Bid Bulletin #1

PROJECT: Northeast Community College
Applied Technology Building, Physical Plant Building, Sitework

DATE: July 3, 2013

PHYSICAL PLANT / APPLIED TECHNOLOGY BUILDINGS CIVIL PACKAGE NORTHEAST
COMMUNITY COLLEGE
801 East Benjamin Avenue
Norfolk, NE 68702-0469
BCDM Project No. 3527-01

SHEET C2-2, WATER MAIN PLAN & PROFILE STA. 306+00 TO STA. 312+00

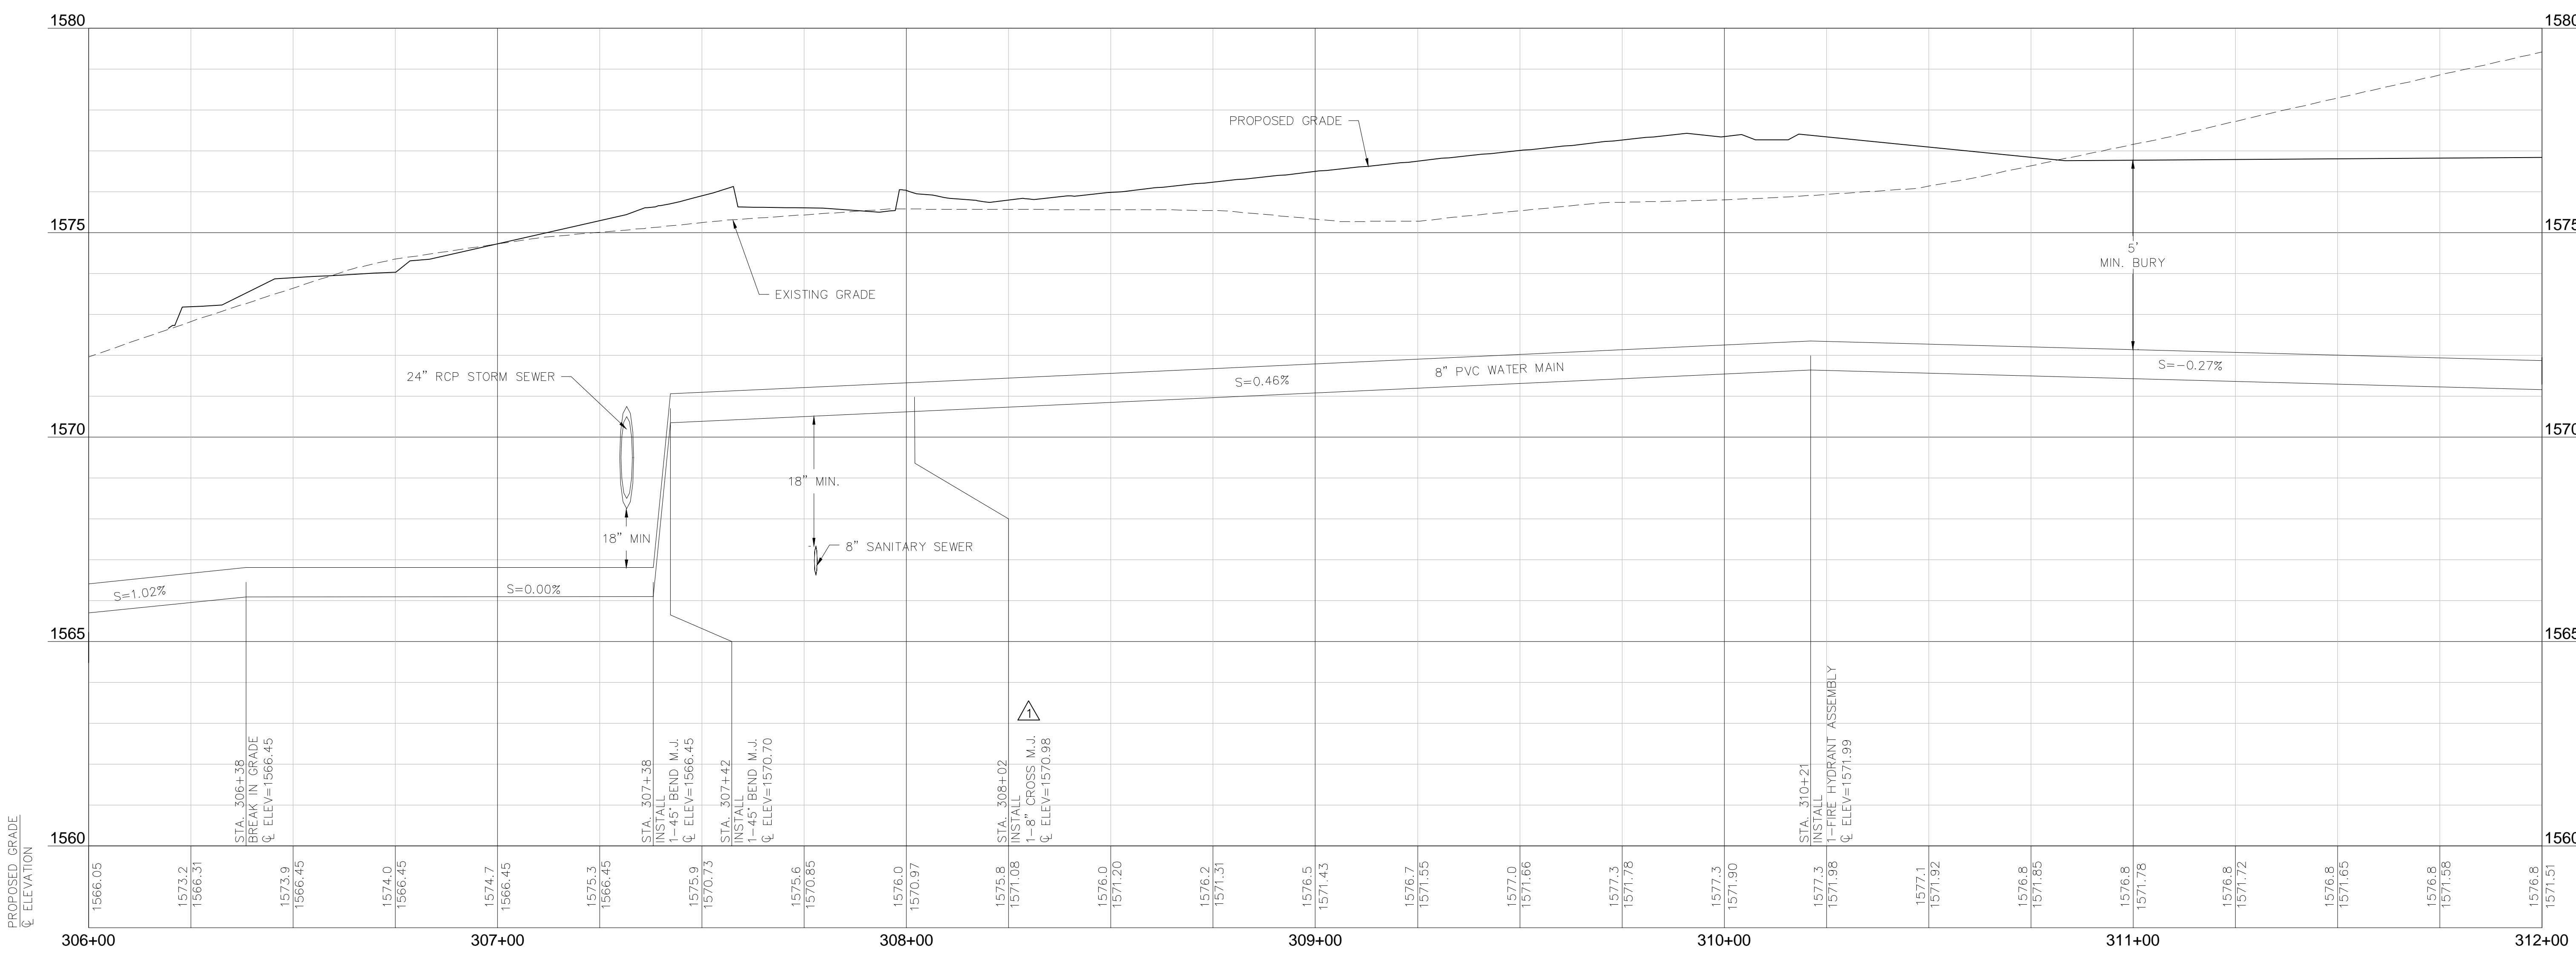
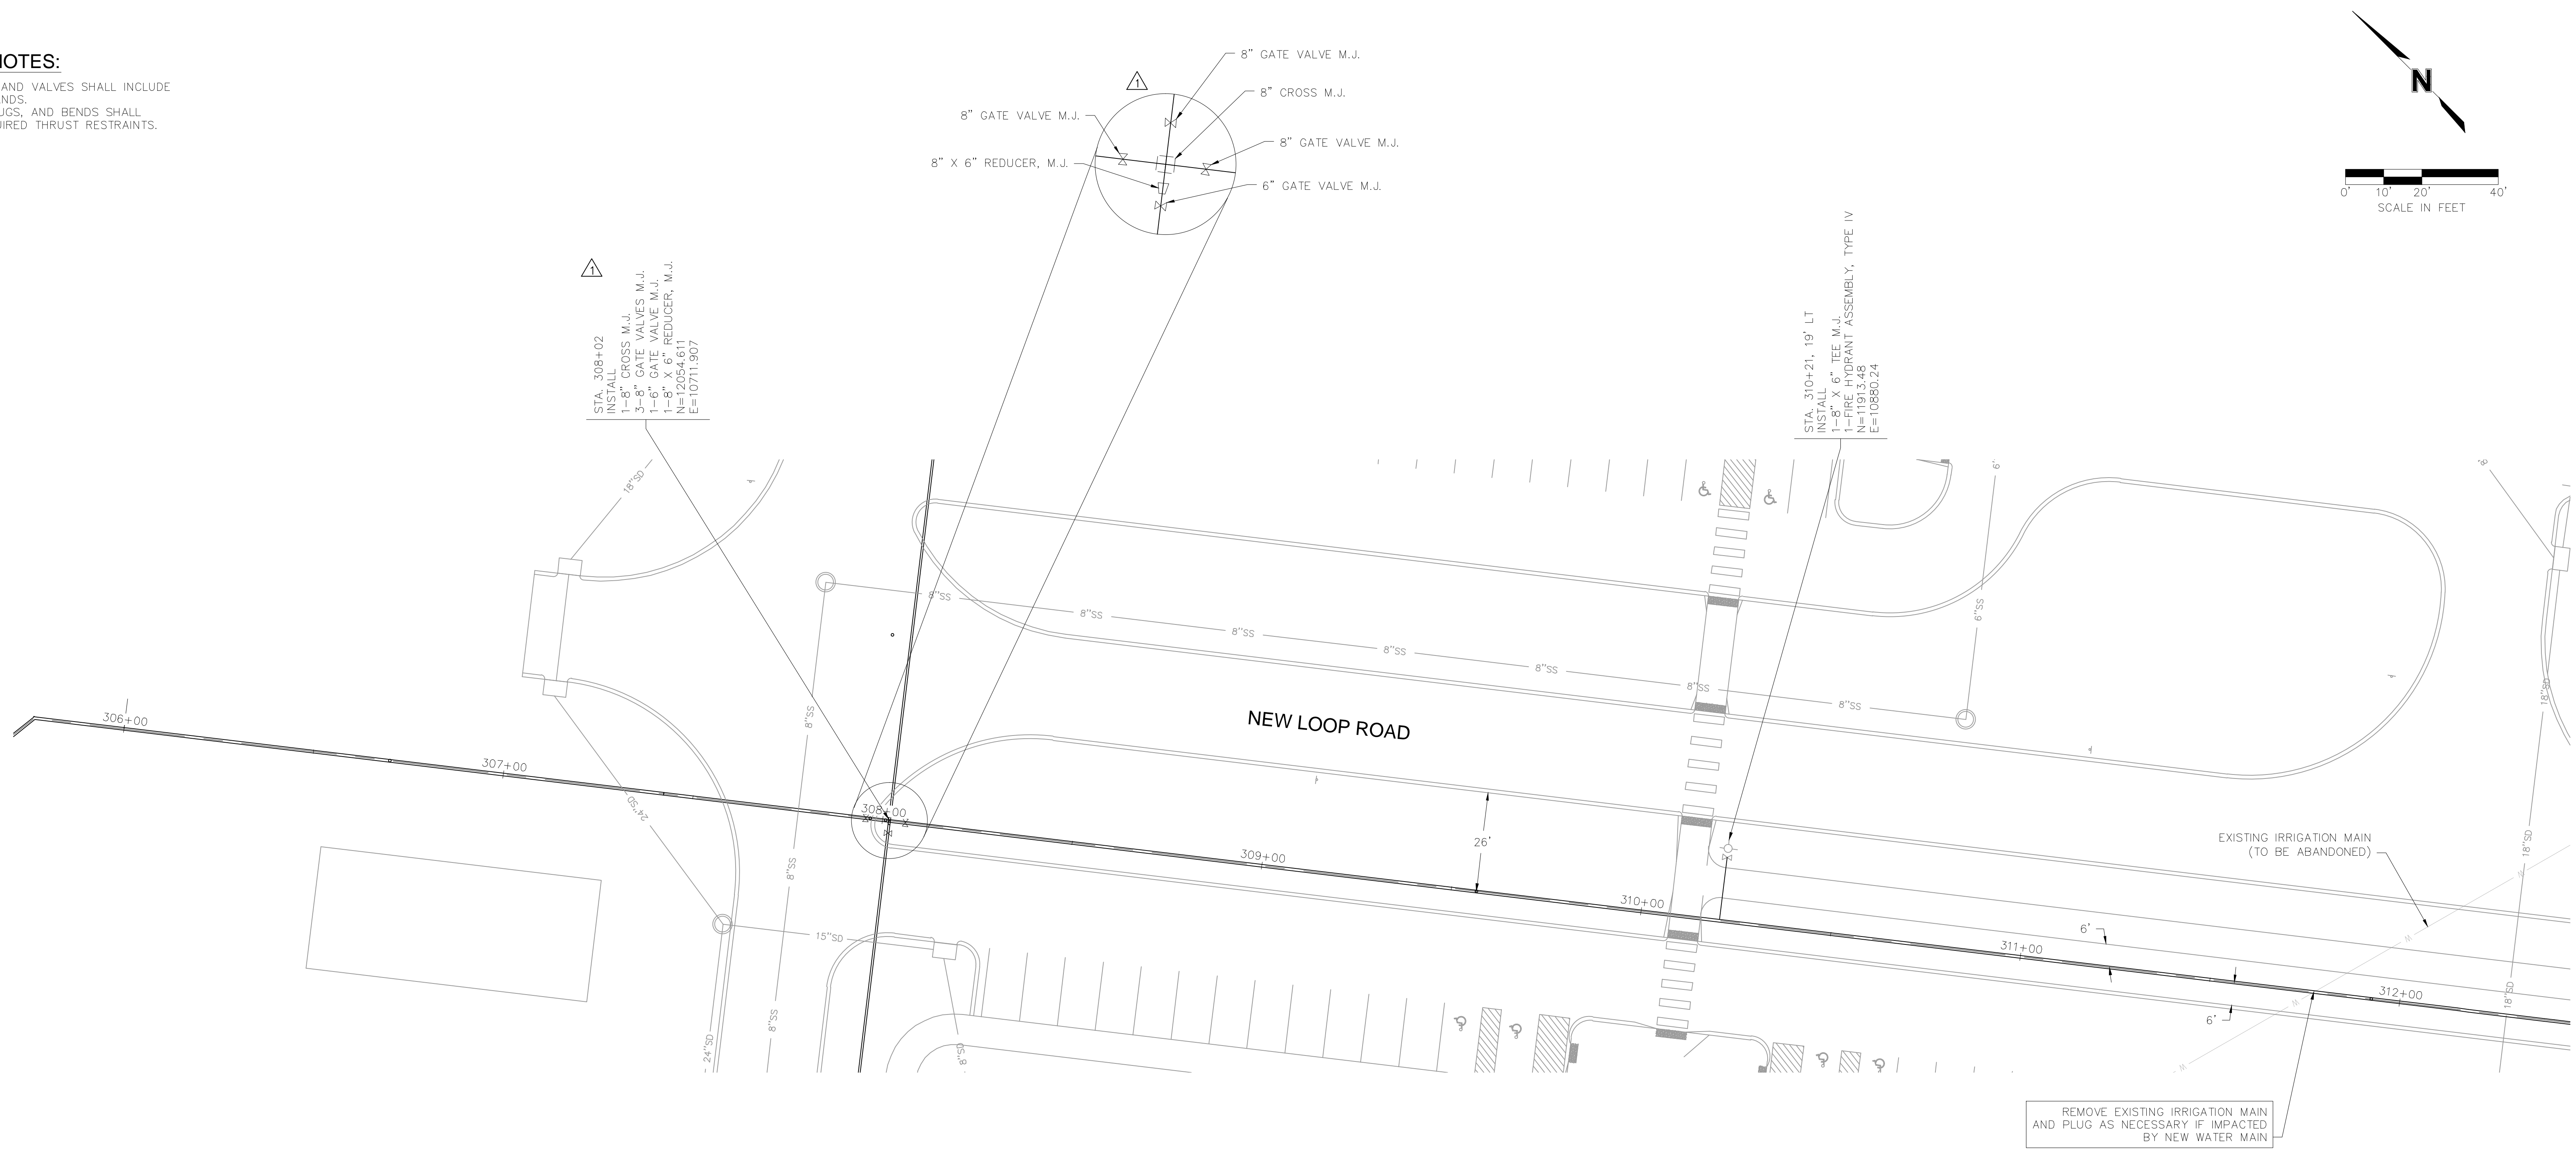
- a. Replace sheet in its entirety with the attached sheet C2-2.
- Size of the cross and a valve at Sta. 308+02 changed from 6" to 8" as shown on the revised sheet.
 - An 8"x6" reducer was added at Sta. 308+02 as shown on the revised sheet.
